Further to our discussions on site earlier this week with regards to the existing garden walls, it has become apparent during the demolition works and exposing the ends of walls on GL C and E, that the walls in their current state have various defects that would deem them unsafe during underpinning works allowing the construction of the new retaining structure. Please see below notes:

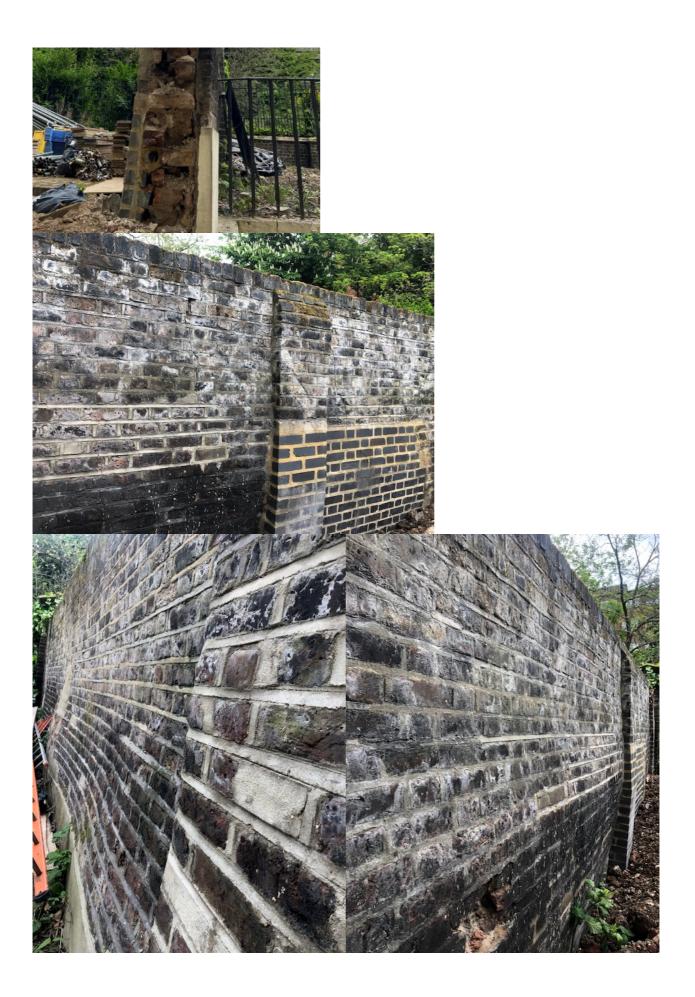
Garden Wall GL C

The wall has a significant lean and we have concerns with the walls stability during underpinning works. It is our recommendation to demolish the wall the extent of the currently proposed underpinning works, to allow the retaining wall works to be carried out. Attached are the current underpinning works and foundation plan for reference.

Garden Wall GL E

The wall is bowing and there is a large crack running between the internal masonry and external leaf. The wall appears to be unstable and unsafe to be maintained during underpinning works. It is our recommendation to demolish the wall the full extent to allow the retaining wall works to be carried out.

For both garden walls, once the retaining structure has been constructed the garden walls may be rebuilt of similar construction onto new mass foundations. Please let us know how you wish to proceed and we will update our drawings accordingly.
